# P802.3bt D3.0 – Mark & Hold v110

Mark & Hold allows a PSE to remain in the mark state for an indefinite amount of time, provided it checks that the PD draws a valid mark current. See full proposal and rationale ➡lukacs\_01\_0517

Figure 145–13 — Top level PSE state diagram

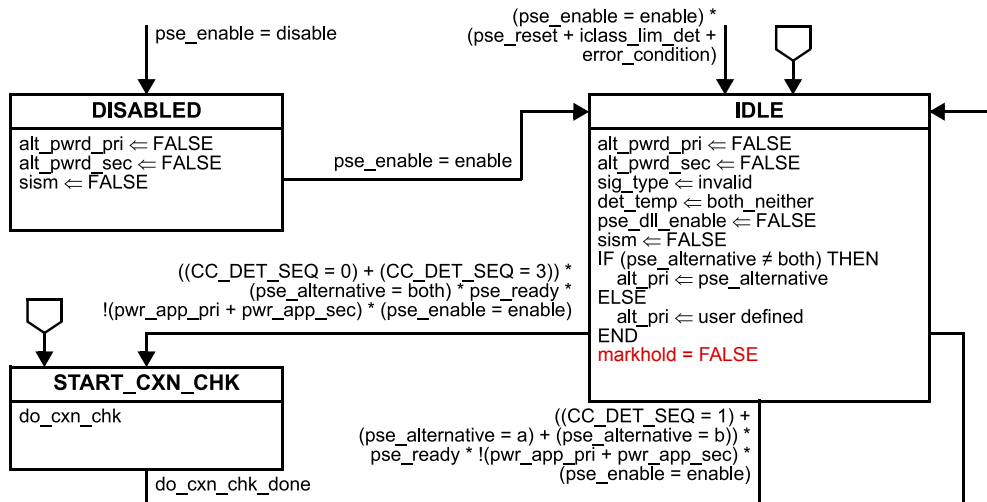
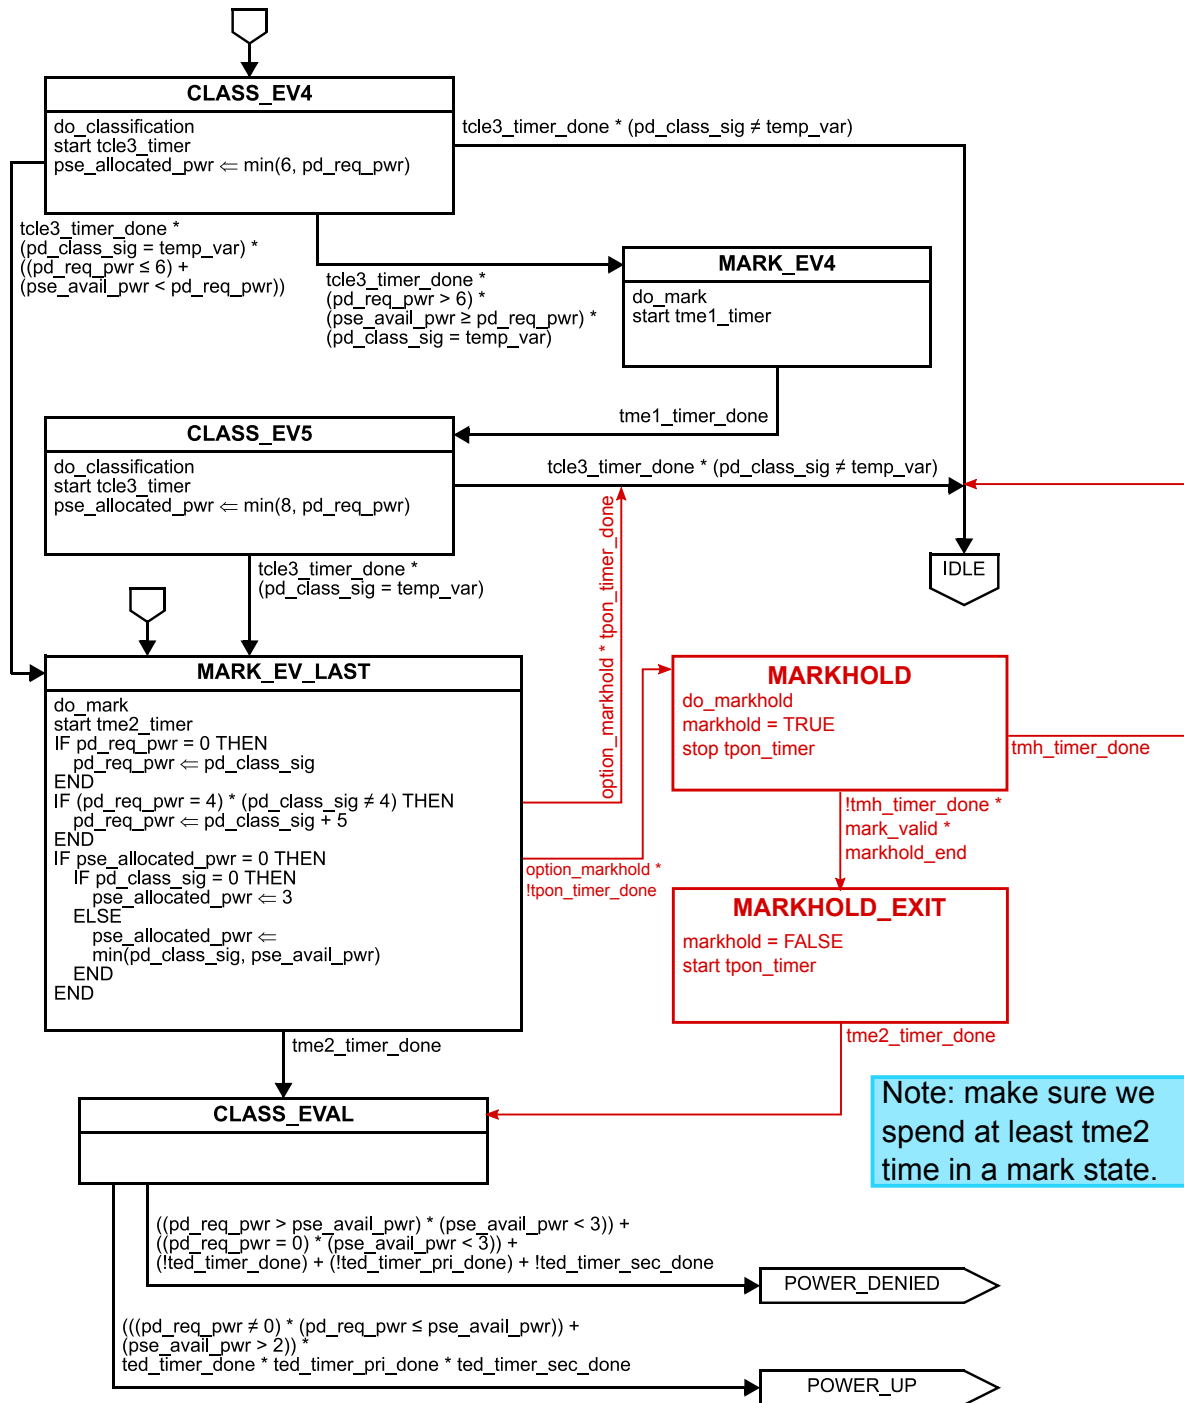
- v110
- Fixed  $T_{pon}$  loophole that would allow an infinite amount of time to be spent between detection and entering markhold.
  - Require that the PSE check the mark current validity at least once by adding “mark\_valid” as a condition for leaving MARKHOLD. This prevents the PSE from zipping through MARKHOLD to reset the  $T_{pon}$  timer.
  - These changes only for single-signature, propagate to dual-signature when reviewed.

Change Figure 145–13 as follows:

Change Figure 145–13 as follows:

Figure 145–16a — PSE mark monitor state diagram for single-signature PDs or 2-pair operation

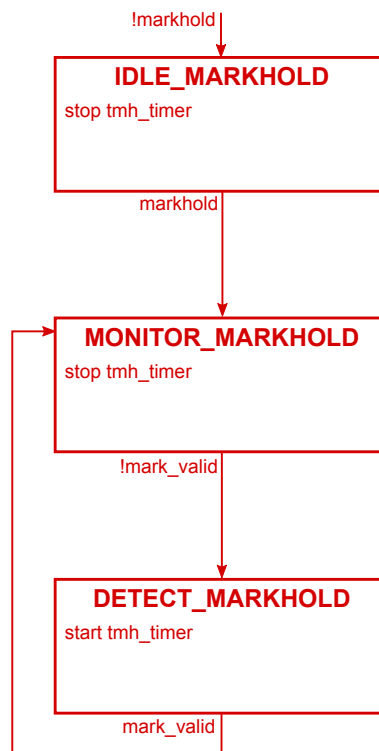
Add a new Figure before 145–17 as follows:

Figure 145–16b — PSE mark monitor state diagram for dual-signature PDs

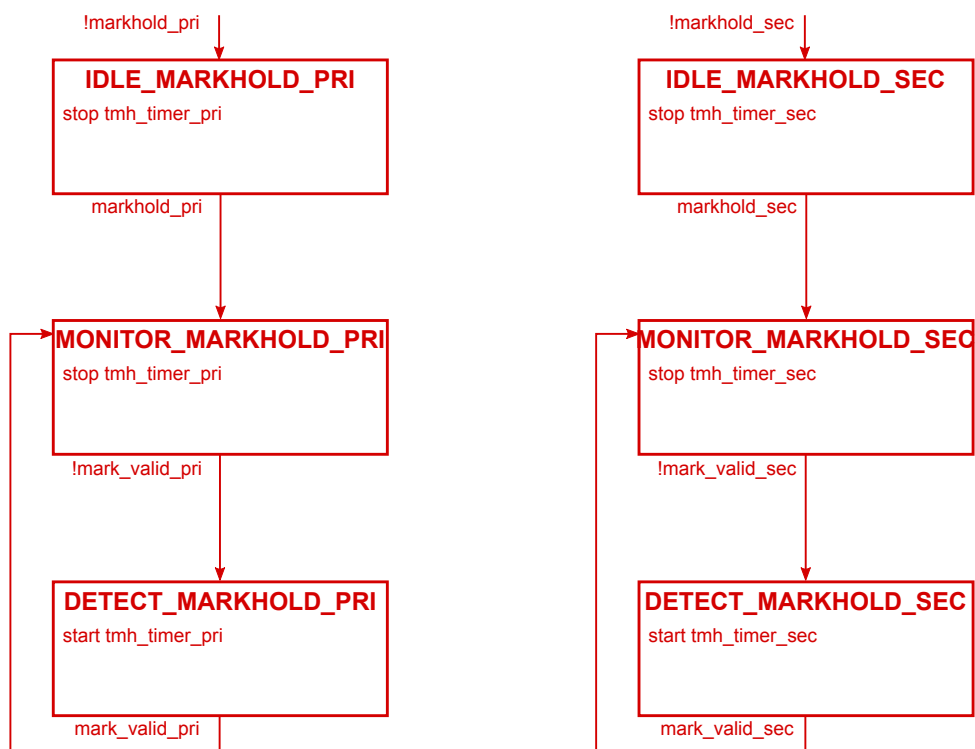
Add a new Figure after 145–16a as follows:
